Re: Gort Town Centre Public Realm Enhancement Project, Gort, Co. Galway
In the townlands of Gort, Co. Galway

Submission re ;Gort Town Center Public Realm Enhancement project

Re: Gort Town Centre Public Realm Enhancement Project

3.2.2 Pedestrian Connectivity Lowry's Lane to Town Core

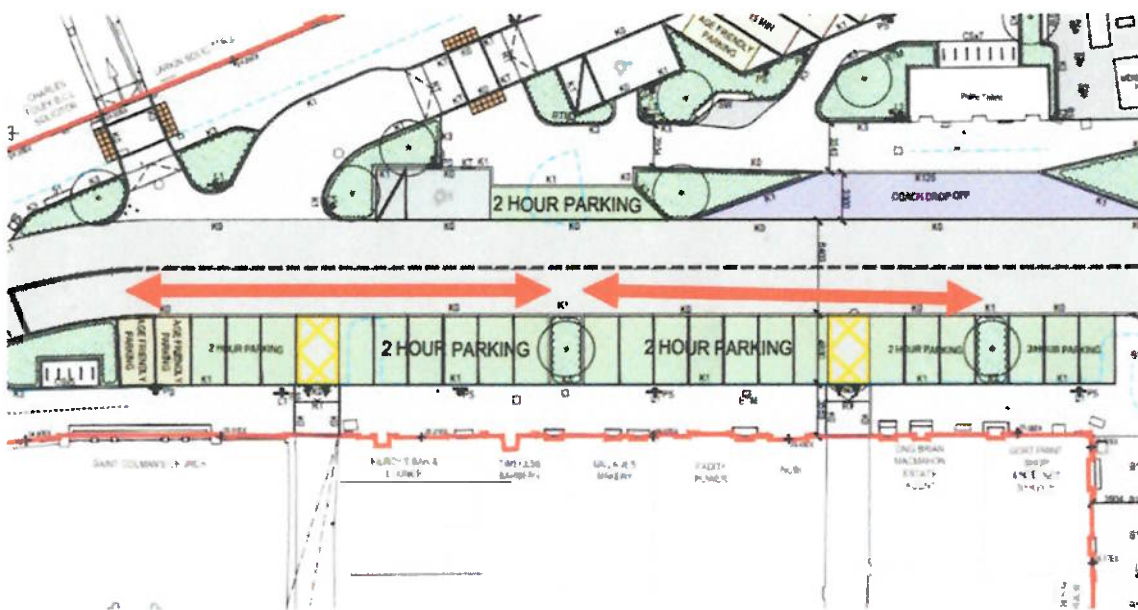
Problem: There is a large car park proposed for Lowry's Lane. The likely desire line for pedestrians from this car park is to walk along Lowry's Lane into Market Street and across to the town core. The pedestrian crossings of Market Street are to both ends, which requires a diversion off the likely desire line. Pedestrians are likely to cross Market Street as a continuation of, or close to, Lowry's Lane.

Hazard: No assistance for sight impaired pedestrians attempting to cross the road in this location is given. The sight impaired pedestrian may errantly enter the carriageway, into the path of oncoming traffic.

Recommendation: The Design Team should provide an uncontrolled crossing closer to the likely pedestrian desire line.

3.2.4 Vehicular Footpath Crossovers

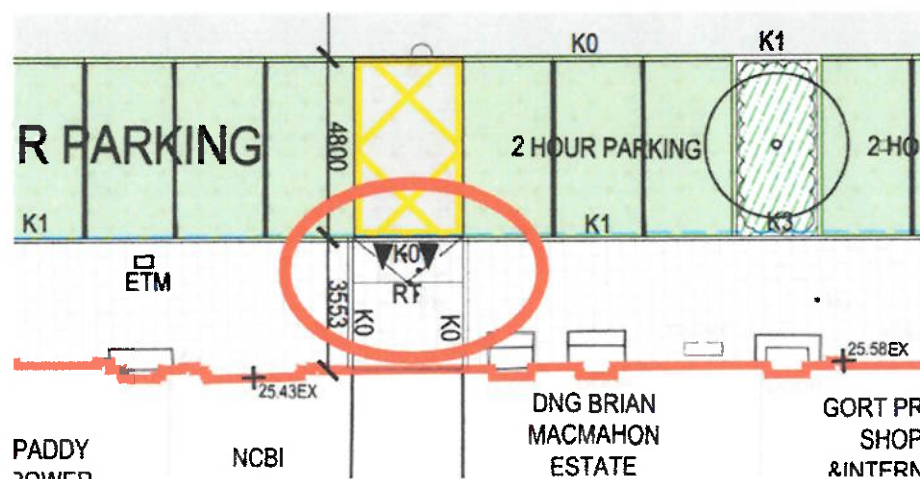
Problem: There are a number of locations where vehicles are permitted to cross the footpath in order to access driveways and back lands. At these locations a flush kerb is indicated to the rear of the car parking bay adjacent to a 100mm face kerb. It appears there is a ramp up from the car park level to the footpath level incorporated into the footpath. There are two problems with this arrangement.

Recommendation: Omit any trip hazards within the footpath and also retain a minimum 60mm kerb face between the footpath and the car parking bay / carriageway.

3.2.5 Driveway Visibility

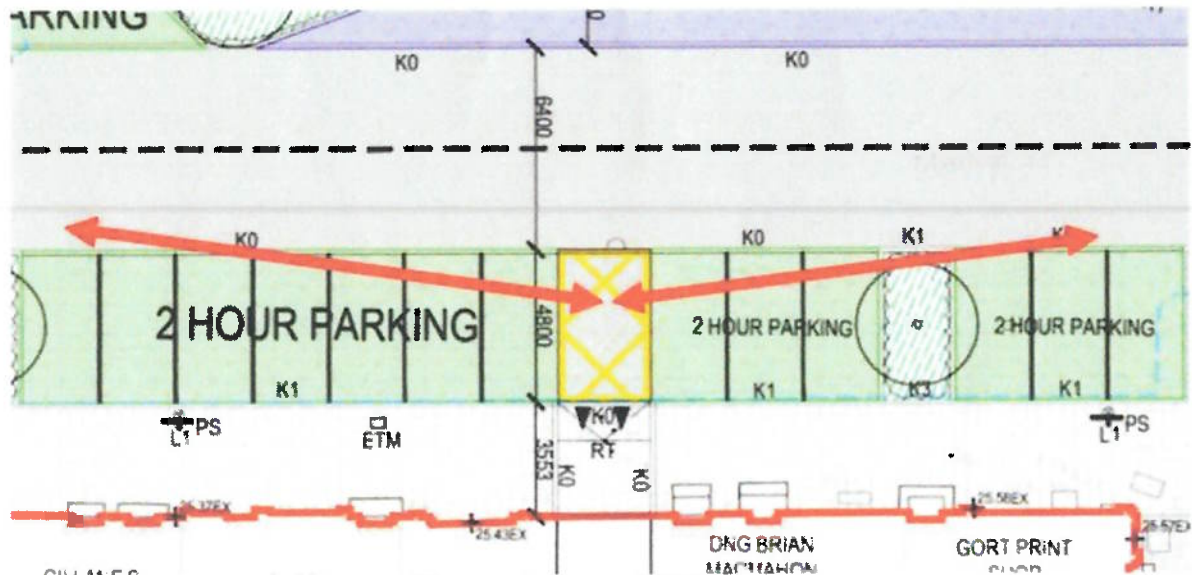
Problem: There are a number of locations where vehicles are permitted to cross the footpath in order to access driveways and back lands in between roadside parking bays. Visibility may be restricted by high sided vehicles in the parking bay.

Hazard: Motorists may proceed into the path of oncoming traffic.

Recommendation: Ensure adequate visibility is provided for all users entering the public carriageway.

3.2.6 Pedestrian Crossings – Visibility

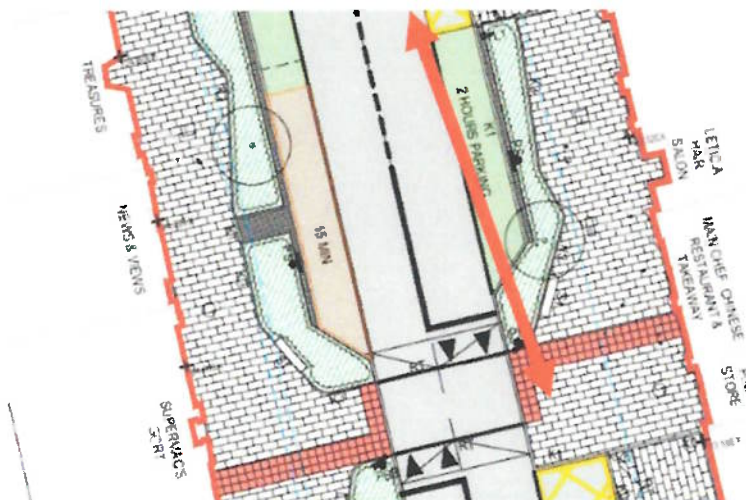
Problem: Visibility to pedestrians waiting to cross the road may be restricted by high sided vehicles parked in adjacent parking bays and/or high vegetation. This problem includes signal-controlled crossing locations, as pedestrians often cross the carriageway even when shown a red man at the light.

Hazard: Pedestrian may step out into the path of oncoming traffic.

Recommendation: the Design Team should ensure adequate visibility is provided. This should include pedestrians waiting to the rear of push chairs at the carriageway edge.

3.2.7 Sharp Kerb Edges

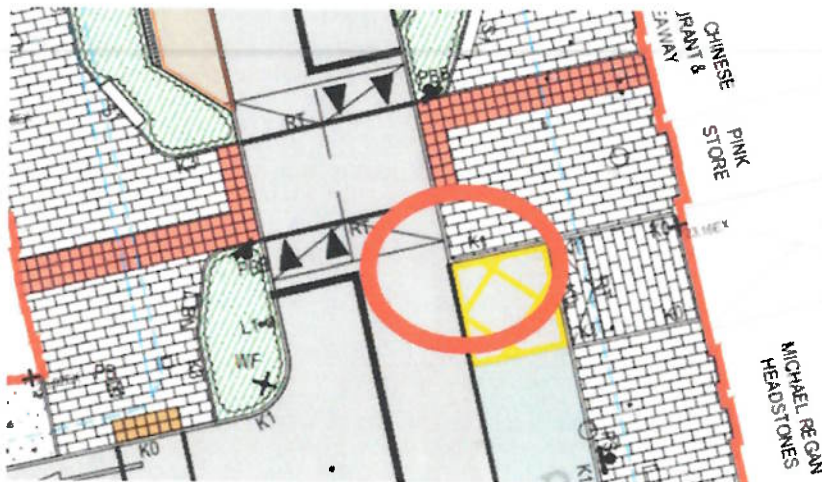
Problem: There are areas within the design that indicate a 100mm high kerb meeting at a 90 degree corner. Vehicles that attempt to turn at these locations are at risk of tyre damage on the kerb.

Hazard: Tyre damage caused at these locations may result in tyre failure elsewhere on high-speed roads.

Recommendation: The Design Team should design out areas of potential vehicle tyre damage.

3.2.8 Disabled User Parking Bays – Church Street and Market Street

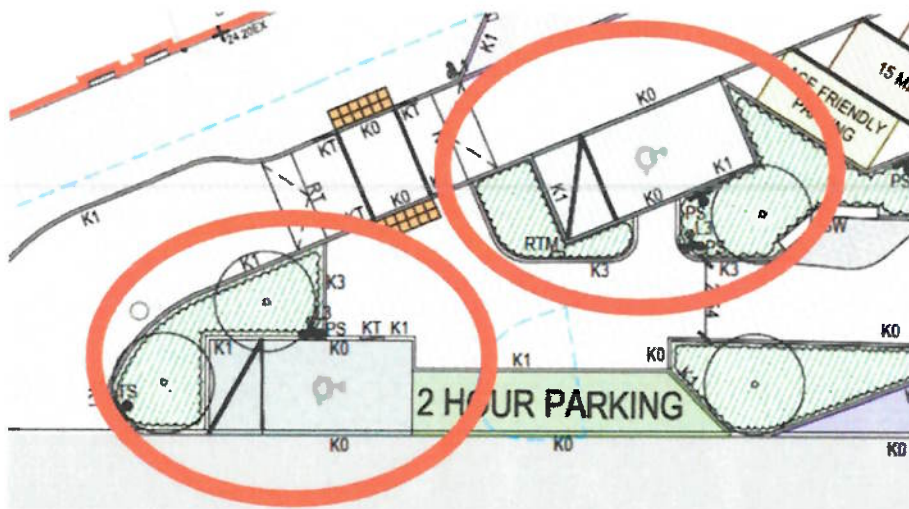
Problem: There are a number of disabled user parking bays located throughout the scheme. Some of these bays have landscaping located between the bay and the footpath. Users with differing disabilities use different methods of accessing / egressing their vehicles. This can include rear door access, rear side doors or front doors.

Hazard: Disabled users without direct access to the footpath may be required to travel on the carriageway prior to accessing the footpath. Impact from passing vehicles may result.

Recommendation: The Design Team should ensure direct access to the footpath can be achieved from all the vehicle passenger doors.

3.2.9 Landscaping Adjacent to Parking Bays

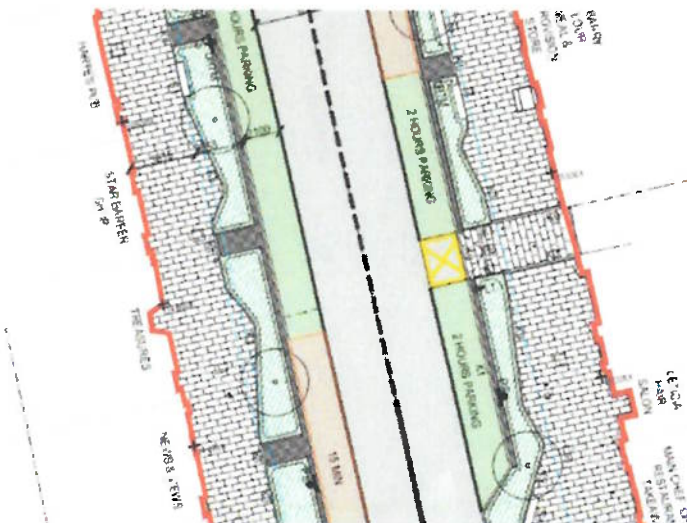
Problem: There are lengths of linear landscaping strips located adjacent to on-line parking bays. Although there are a number of paved links from the footpath at the rear of the landscaping through to the parking bay, these links will only be of use if the parked vehicle directly aligns with the paved link and even then, they will only be of use for the passenger adjacent to this link.

Hazard: Vehicle drivers and passengers are likely to walk within the carriageway until they can find a paved link through to the footpath. This may involve walking the full length of the parking bay on the carriageway. Impact from passing traffic may result.

Recommendation: The Design Team should omit the landscaping and provide direct connectivity to the footpath for all vehicle passengers.

3.2.10 Coach Drop-off Bay

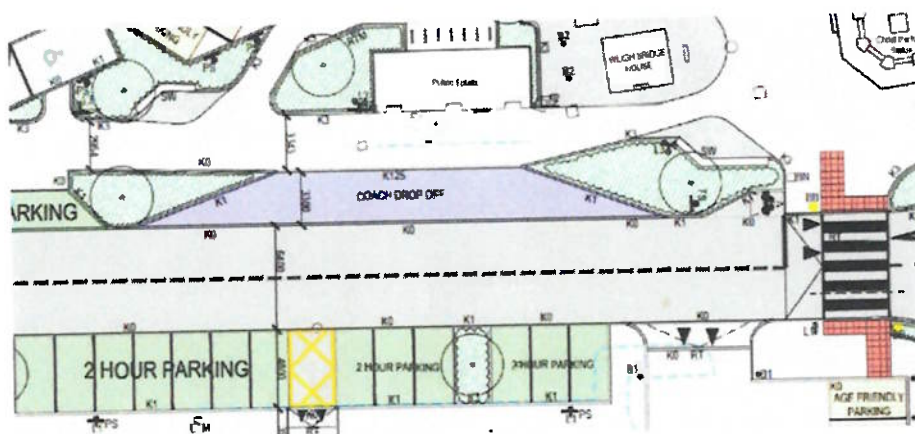
Problem: The coach drop-off bay is located on the northern side of Church Street. No information has been provided by the Design Team to the route of the coach. There is concern the coach may arrive from the M18/R458. If this is the case the coach will need to turn on or near to Church Street in order for the passenger door to be adjacent to the footpath, or passengers will alight into the carriageway. There is no obvious location for the coach to undertake a 'U' turn along Church Street.

Hazard: The coach may attempt to reverse into one of the side streets off Church Street. Impact with other road users may result. If passengers alight into the carriageway, impact from passing traffic may result.

Recommendation: The Design Team should ensure the coach arrives from Church Street west and does not need to undertake a 'U' turn in order to achieve a drop off or collection.

3.2.11 Church Street – Perpendicular Parking Bays

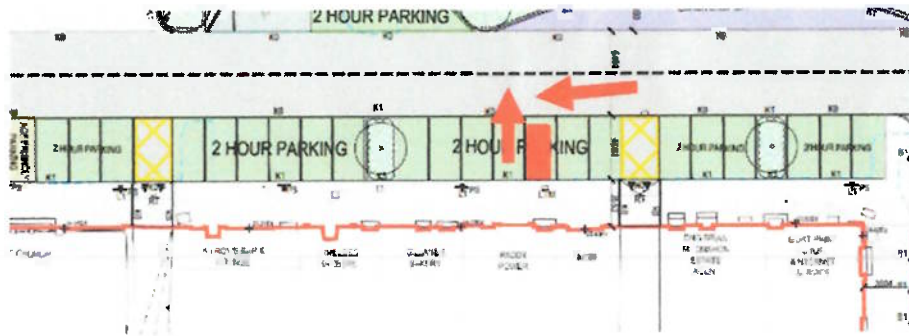
Problem: There is a long run of perpendicular parking bays on Church Street. Users attempting to exit these bays may have visibility to oncoming traffic restricted by adjacent parked high-sided vehicles.

Hazard: Exiting motorists may be struck by passing mainline traffic.

Recommendation: The Design Team should provide a buffer strip between the carriageway and parking bay, such that mainline traffic can observe a moving vehicle and slow/stop to permit this vehicle safe egress.

3.3.1 Crowe Street Car Park – Pedestrian Access

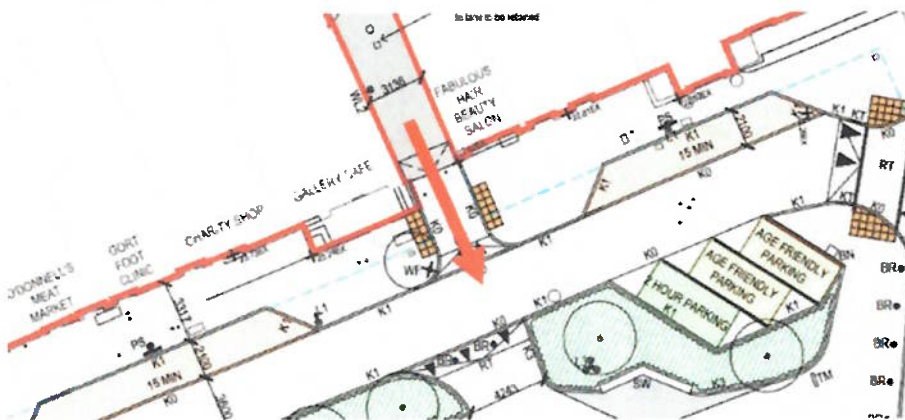
Problem: It appears from the drawings that pedestrian access to/from the car park is intended to be achieved via Lowry's Lane. This lane is very narrow and currently used by vehicles to access the rear of premises.

*Even for pedestrians =
Absolutely the whole way down!
Dangerous *
as there is
No Room*

Hazard: Motor vehicles are unlikely to have sufficient room to pass wheelchair users. The motorist may decide to reverse back onto Market Street. Impact with pedestrians on Market Street may result.

3.3.3 Crowe Street Car Park – Visibility

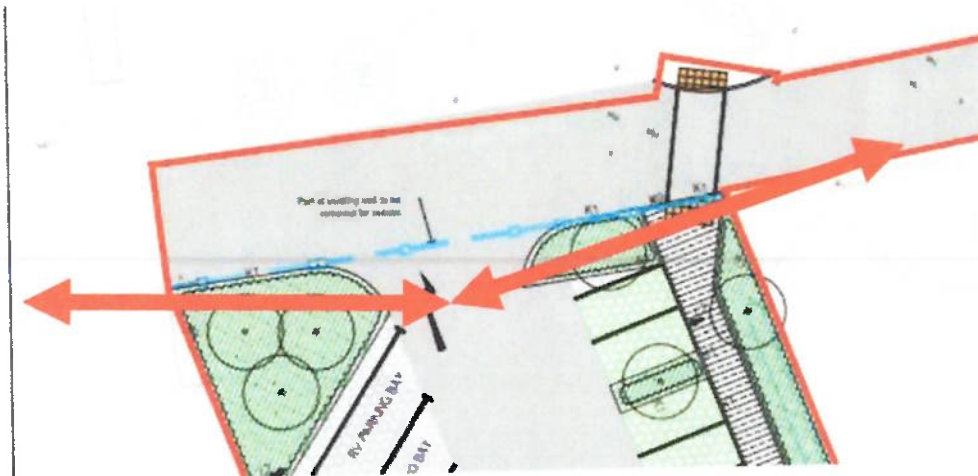
Problem: Visibility on exit from the car park may be restricted in either direction by boundary walls / vegetation.

Hazard: Car park users may exit into the path of oncoming traffic.

Recommendation: The Design Team should ensure suitable visibility is provided in both directions.

3.3.4 Crowe Street Car Park – RV Parking

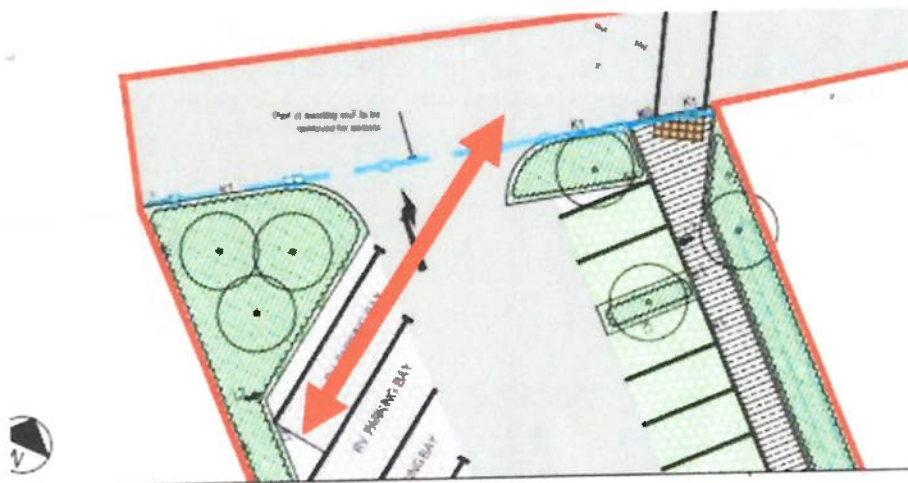
Problem: RV parking is indicated near the entrance to the car park. It is not clear how long vehicles are meant to enter / exit these spaces. It is likely the users will drive forward into the space and reverse back out of the car park junction in order to exit.

Hazard: Impact with vehicles entering the car park may result.

3.3.8 Crowe Street (Ennis Road R380) Controlled Crossing

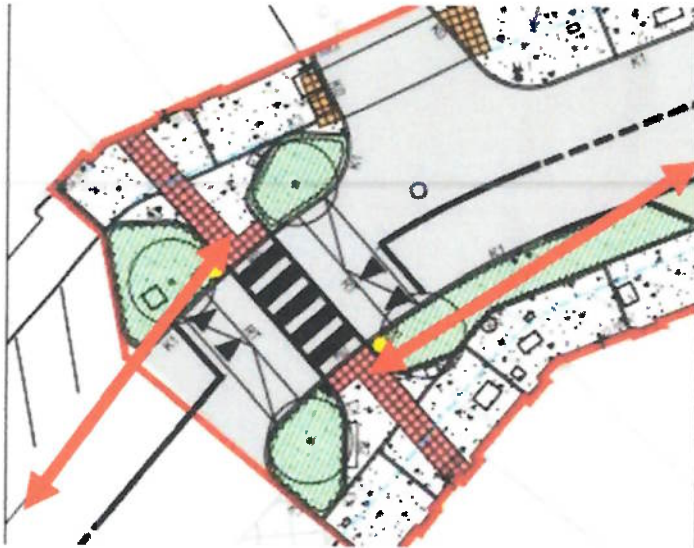
Problem: The controlled crossing located to the front of “The Gift Box / An Post” is located on a steep downhill section of carriageway. Vehicles approaching from the south may have their ability to stop compromised by the steep carriageway, particularly in wet or frosty conditions.

Hazard: Vehicles may overshoot the crossing, impacting with pedestrians.

Recommendation: The Design Team should provide enhanced friction material on the carriageway surface.

3.3.10 Gararghbeg Road – Pedestrian Crossing

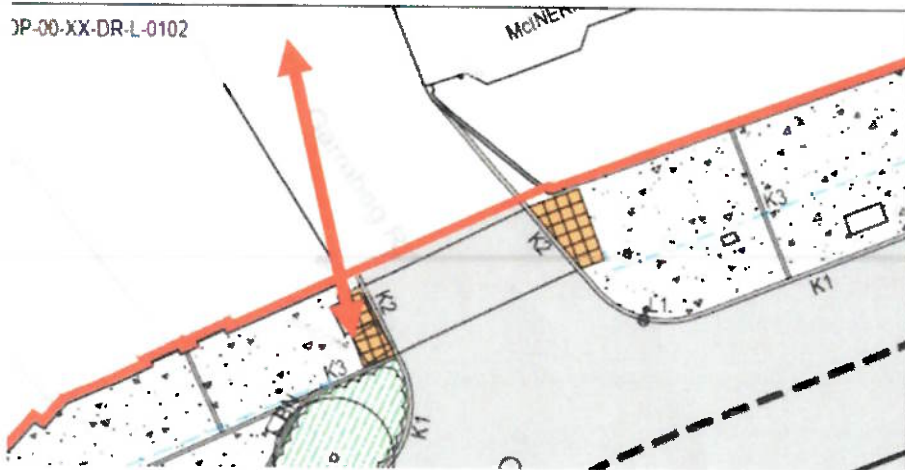
Problem: The tactile paving / pedestrian crossing on Gararghbeg Road is located such that pedestrians crossing from west to east will have very limited sight of vehicles approaching on Gararghbeg Road.

Hazard: Pedestrians may step into the carriageway into the path of oncoming vehicles.

3.3.11 Church Street – McInerney Auctioneers and Dwelling House

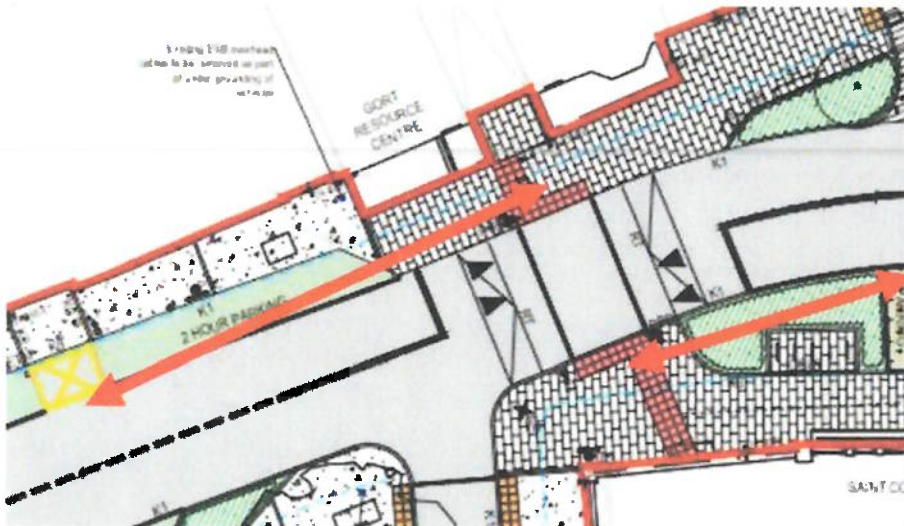
Problem: There is existing off-street parking located at McInerney Auctioneers and a dwelling house at the corner of the Gort Family Practice. The proposals include for the provision of a 100mm high kerb across both entrances and also a parking bay.

Hazard: Riders of powered two-wheeled vehicles may lose vehicle control when attempting to cross the kerb. Additionally high sided vehicles in the parking bay may restrict visibility on exit from the driveways.

Recommendation: The Design Team should provide suitable entrance to the parking areas, with suitable visibility splays.

3.3.13 Barrack Street – Controlled Crossing at R458 Junction.

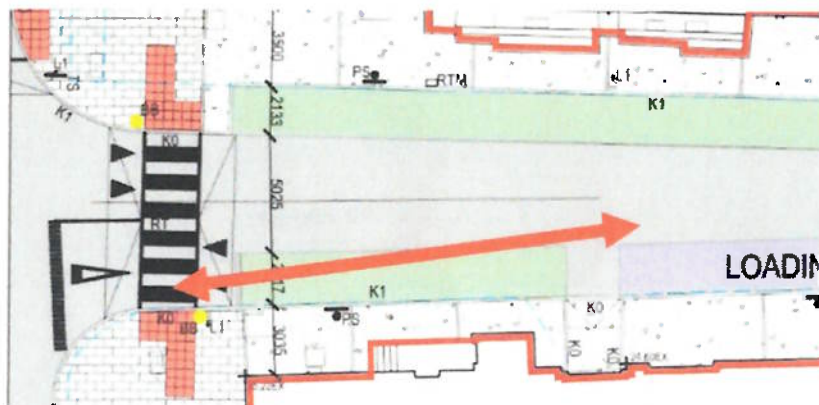
Problem: There is a parking bay located to the east of the controlled crossing. High sided vehicles within the parking bay may restrict driver visibility to the waiting or northbound crossing pedestrian.

Hazard: Pedestrians may commence their crossing unsighted to oncoming motorists.

Recommendation: The Design Team should reduce the carriageway width at the mouth of the junction such that the southern side of the crossing is visible to approaching motorists.

3.3.14 Coach Parking Near Christ the King Statue.

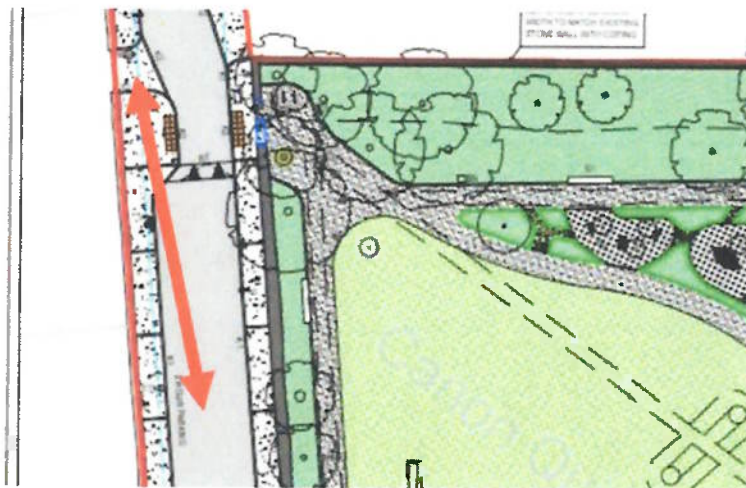
Problem: The coach parking is indicated with a K100 kerb adjacent. Some users may have difficulty in stepping from the kerb up onto the bus.

Hazard: Trip/fall incidents may result.

Recommendation: The Design Team should replace the K100 kerb with a Bus Kerb.

3.3.17 Georges Street – Pedestrian Cross Outside Supermac's

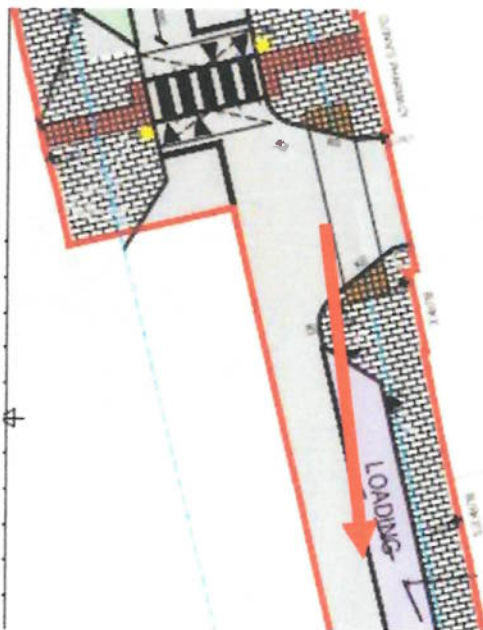
Problem: There is a pedestrian crossing proposed on Georges Street, outside of the Supermac's premises. Currently there is a double kerb in this location as the carriageway is substantially lower than the footpath. There is concern that the footpath to the crossing will be excessively steep.

Hazard: Mobility-impaired users may fall due to the gradient.

Recommendation: The Design Team should ensure all footpath gradients comply with current best practice.

3.3.19 Station Road – Pedestrian Crossing Visibility

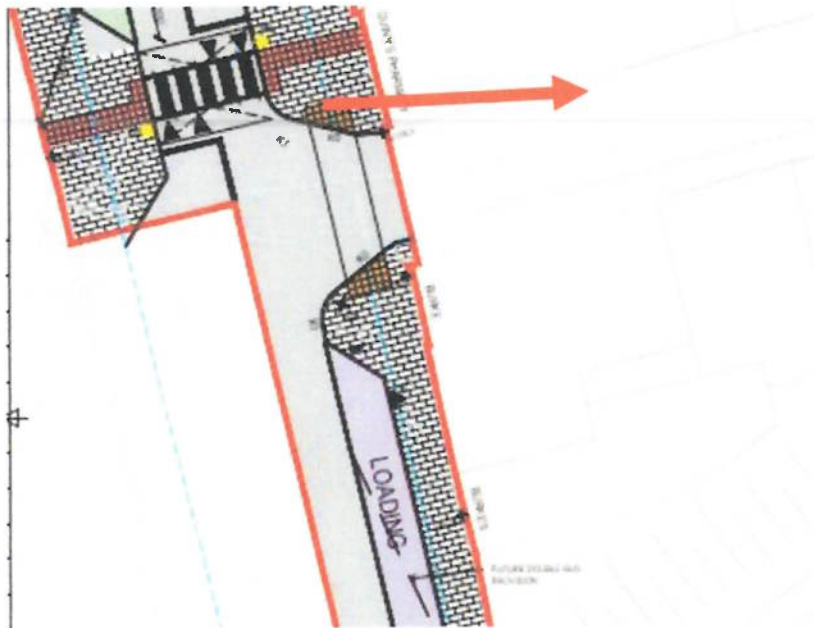
Problem: Pedestrians crossing north south of Station Road have their visibility to traffic exiting Station Road restricted by the building.

Hazard: Pedestrians may commence their road crossing and be subject to vehicle strikes.

3.3.20 Gort Medical Centre – Car Park

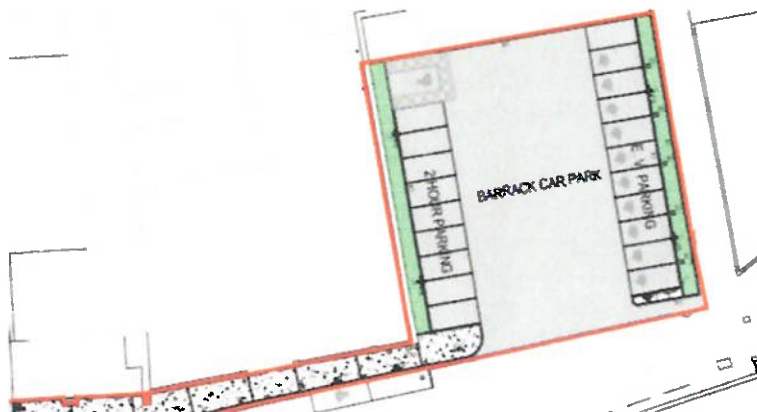
Problem: Motorists' visibility to pedestrians crossing the entrance to Gort Medical Centre is very restricted, both by boundary walls and the angle of the entrance. It was noted during the site visit this car park is very busy and has a high turnover rate.

Hazard: Pedestrian / vehicle collisions may result.

Recommendation: The team, in consultation with the medical centre, should undertake works to improve the existing car park access.
